# MIDDLETON STONEY ROAD, BICESTER.

## PROPOSED PHASE 1B WORKS

### Stage 1 Road Safety Audit

**SG-AA-2024-4431-RSA1**

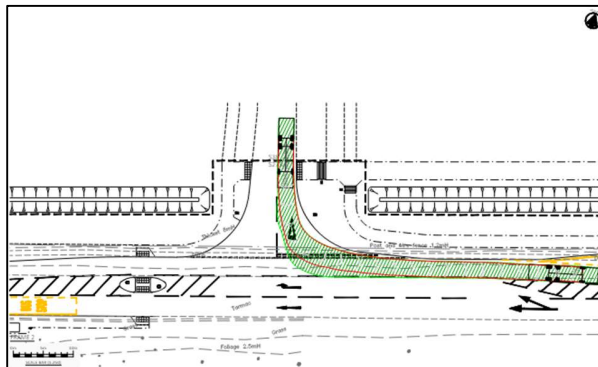
SUMMARY: Risk of NMU incursions into swale with risk of drowning

The scheme proposals include the provision of swales in close proximity to shared use facilities / cycleways and footways. From the information provided, some of the proposed swales are to be a minimum of 0.6m deep. With the absence of any features to protect NMU's from incursions into the swale, NMU's particularly cyclists may be at risk of exposure to level differences. This would be further exacerbated during periods of heavy rainfall where storm water may create a drowning hazard for any such incursions.

The Audit Team recommend providing measures to protect NMU's from incursions into the proposed swales throughout the scheme extents.

## APPENDIX A: LOCATION PLAN

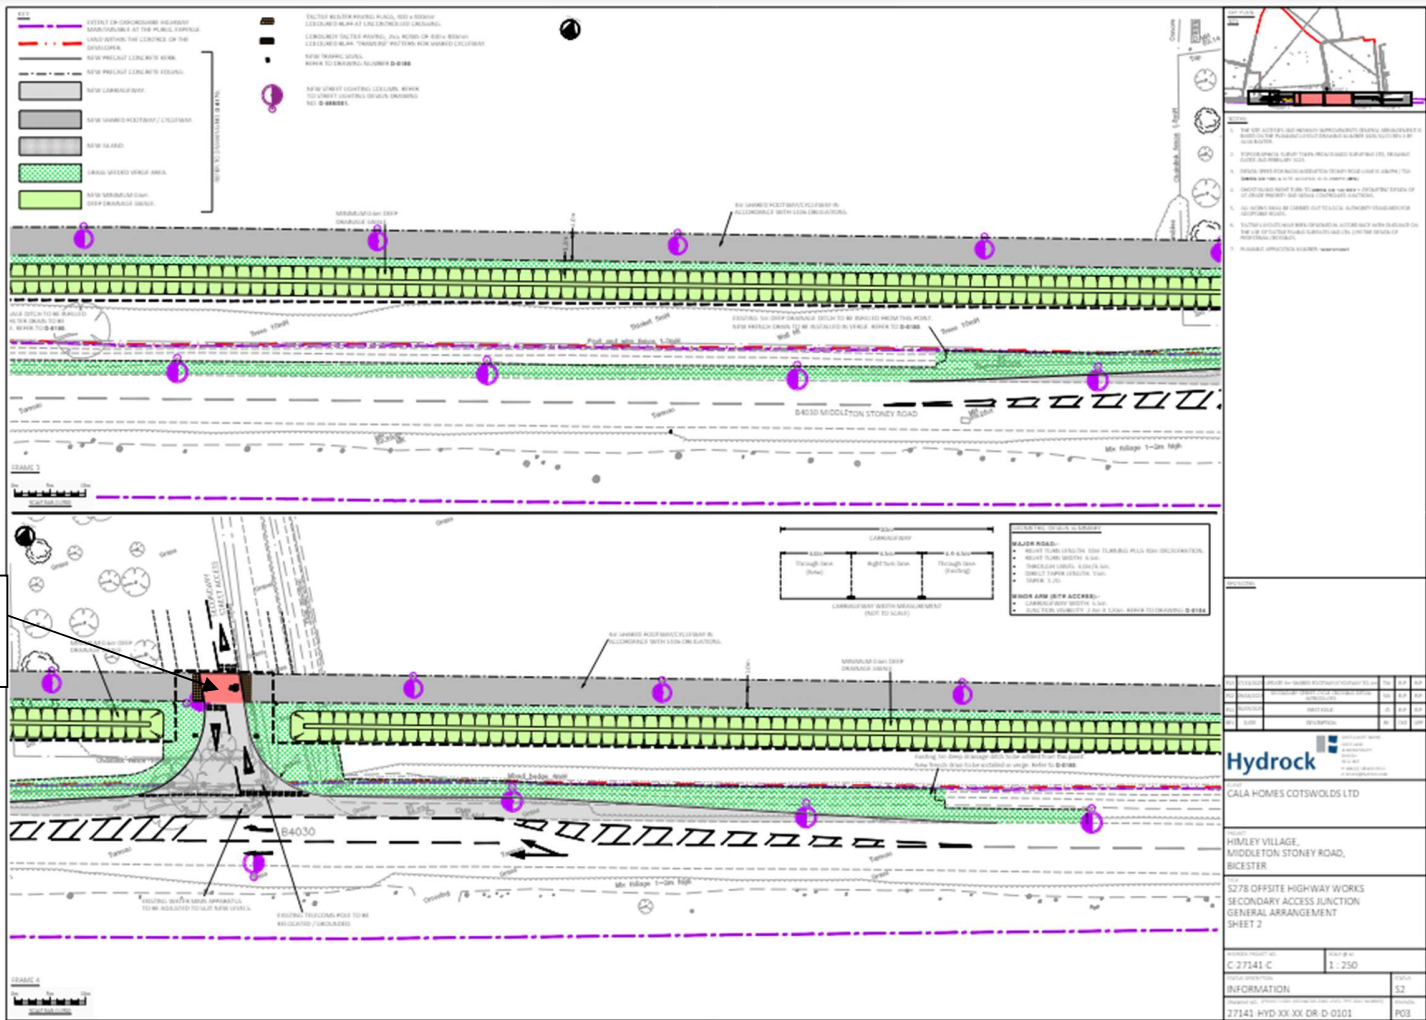
SUMMARY: Risk of vehicles speeding in excess of the posted speed limit

The scheme proposals include extending the existing 40mph speed limit westwards to include the location of both the vehicular accesses into the proposed development. Motorists travelling in an eastbound direction west of the development may be travelling at or above the National Speed Limit (ie 60mph) on this approach. Although 40mph signs have been proposed, the provision of signage alone may not be sufficient for eastbound road users to comply with the change in speed limit ahead. Inappropriate speeds within the vicinity of the proposed vehicular accesses/crossings may result in collisions of all types, including injury to NMUs using the crossing. Collisions involving excessive speeds will also likely increase the severity of collisions.

SUMMARY: Risk of vehicle to bus type collisions and/or vehicles striking kerb/loss of control

The alignment of the eastbound lane in relation to the proposed bus lay-by is such that it directs road users into the bus lay-by where they may either come into conflict with a bus stopped here or the nearside kerb. This may increase the likelihood of vehicles colliding with busses or single vehicle loss of control collisions as a result of sudden manoeuvring/striking the kerb.

SUMMARY: Vegetation within visibility splays

The scheme proposals indicate visibility splays either side of the proposed accesses onto Middleton Stoney Road. It was noted during the site inspection that there is existing vegetation in the vicinity of the proposed accesses. Obstruction of the visibility splays may increase the likelihood of failure to give way by motorists emerging from the site and a risk of associated vehicle on vehicle type collisions.

The Audit Team recommend additional measures including the provision of signage is provided to achieve compliance with the proposed 40mph speed limit at the new highway features.

The Audit Team recommends that the eastbound near-side kerb alignment is adjusted to provide a smoother alignment for road users. This could be achieved by providing a more conventional bus lay-by arrangement than that proposed.

The Audit Team recommend that the existing vegetation is cut back and adequately maintained, in order that the proposed visibility splays are kept clear of obstruction.

3.4, 3.5 & 3.6

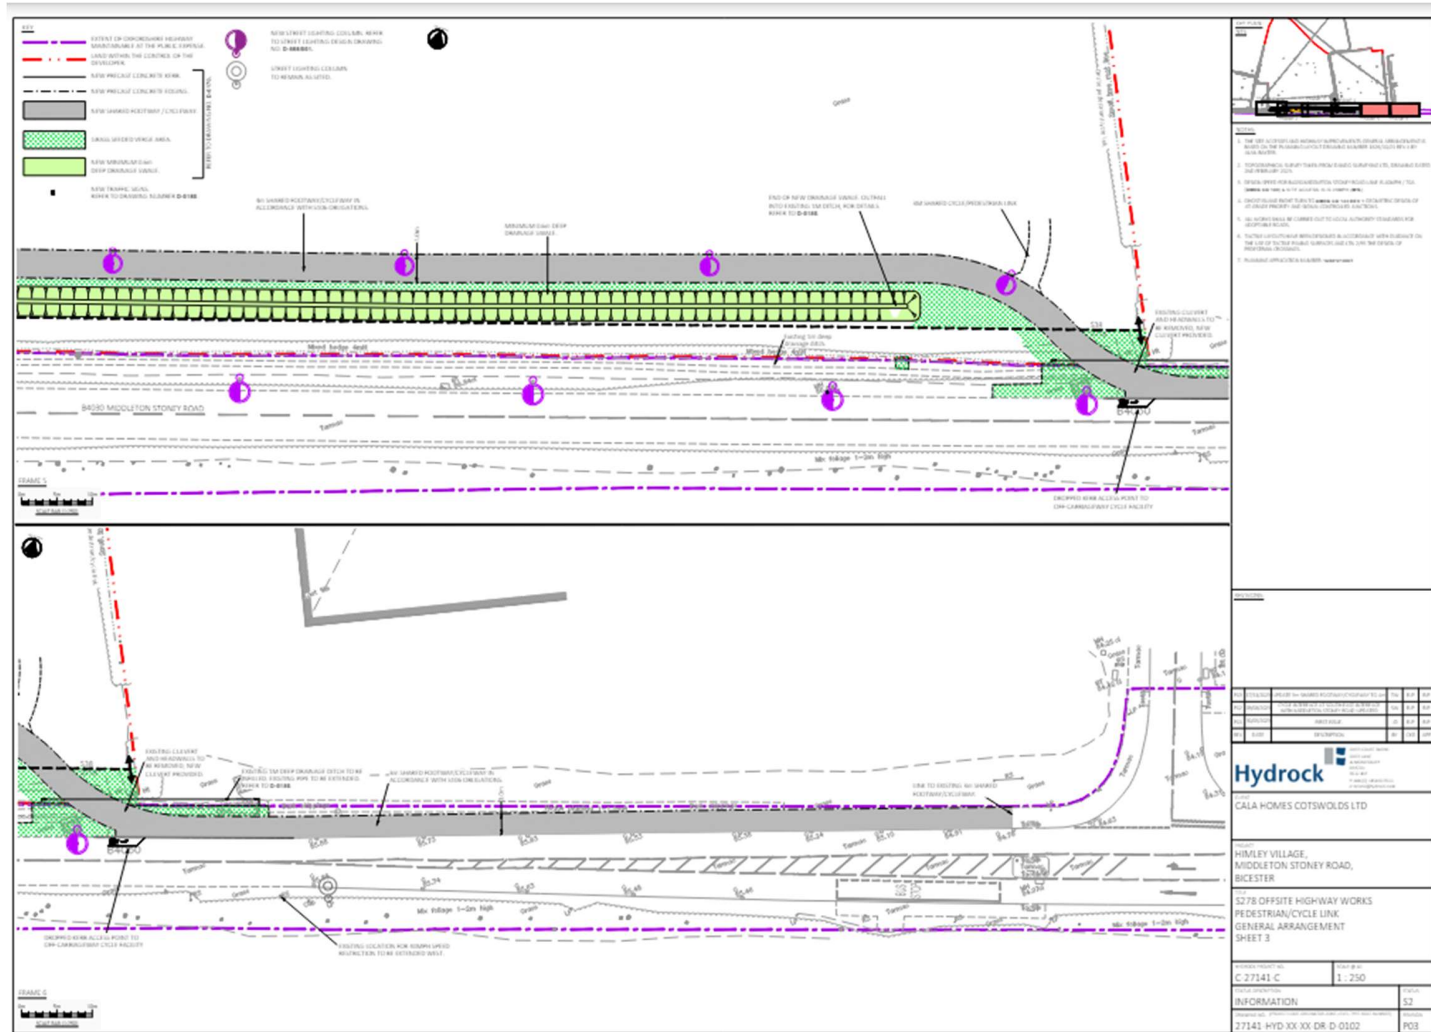
SUMMARY: Insufficient carriageway geometry

From the vehicle swept path analysis provided as part of the scheme submission, it is evident that larger service/refuse vehicle cannot turn left from the site without encroaching onto the right turn lane. Insufficient carriageway widths to accommodate long wheel based vehicular turning movements may increase the risk of vehicle on vehicle side impact/sideswipe type collisions.

SUMMARY: Risk of vehicle overhang on mainline carriageway.

It is unclear from the drawings provided whether there will be sufficient carriageway width between the edge of the give-way and the mainline carriageway of Middleton Stoney Road. Insufficient width may result in vehicles entering the proposed access overhanging the mainline carriageway when stopped to give-way to cyclists at this location. This may increase the risk of vehicle on vehicle side impact type collisions and possible injury to vehicle occupants.

The Audit Team recommends providing adequate carriageway geometry to ensure that all likely vehicle types to use this junction can carry out turning safely and without obstruction.

The Audit Team recommend that sufficient carriageway length is provided between the proposed give-way and the mainline carriageway to accommodate all vehicles expected to use this junction.
